Access Compliance Report

Public Rights-of-Way

Intersection ID: 7280	Main Street: N_I-85_EXIT_41_RA	Cross Street: W_SUGAR_CREEK_RD	Location: NW
ADA ID: 7D014C1EDAE1	Ramp Type: Perp	Initial Pass/Fail: Fail	Overall Compliance: No
		Severity Score: 37.5

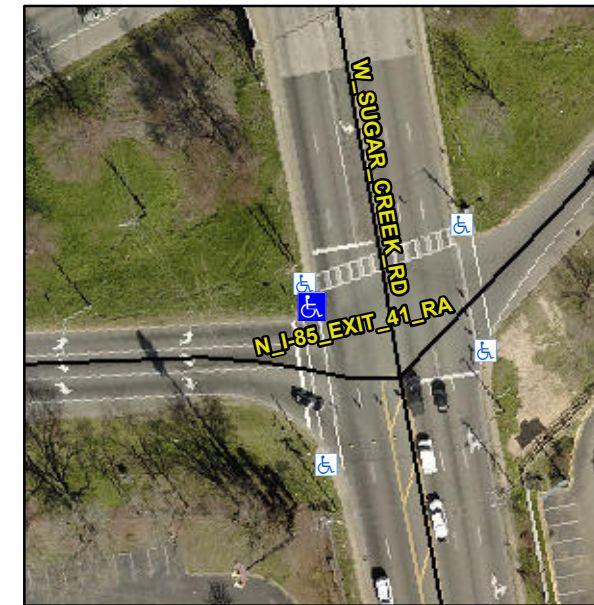
Not Found, R304.2.2, R304.5.3

Compliance	Description	Data	Compliance	Description	Data
N/A	Ramp Length (in)	53.0	No	Ramp Slope (%)	11.3
Yes	Ramp Width (in)	48.0	No	Ramp XSlope (%)	7.3
N/A	Flare Type LT	N/A	N/A	Flare Type RT	N/A
N/A	Flare Slope LT (%)	N/A	N/A	Flare Slope RT (%)	N/A
N/A	Flare Traversable LT?	N/A	N/A	Flare Traversable RT?	N/A
N/A	Landing Length (in)	N/A	N/A	DWS Provided?	N/A
N/A	Landing Width (in)	N/A	N/A	DWS Contrast?	N/A
N/A	Landing Slope (%)	N/A	N/A	DWS Length (in)	N/A
N/A	Landing X Slope (%)	N/A	N/A	DWS Full Width?	N/A
N/A	Landing Curb? (Y/N)	N/A	N/A	DWS Offset (in)	N/A
N/A	Shared Landing?	N/A			
N/A	Gutter Ponding?	N/A	N/A	Gutter Slope (%)	N/A
N/A	Gutter Lip Ht (in)	N/A	N/A	Gutter X Slope (%)	N/A
N/A	Painted X Walk1?	Yes	N/A	Painted X Walk2?	N/A
	X Walk 1 Direction	To S		X Walk 2 Direction	N/A
N/A	X Walk 1 Width (in)	96.0	N/A	X Walk 2 Width (in)	N/A
	X Walk 1 Slope (%)	0.7		X Walk 2 Slope (%)	N/A
	X Walk 1 X Slope (%)	4.3		X Walk 2 X Slope (%)	N/A

Remove & Replace Entire Ramp.
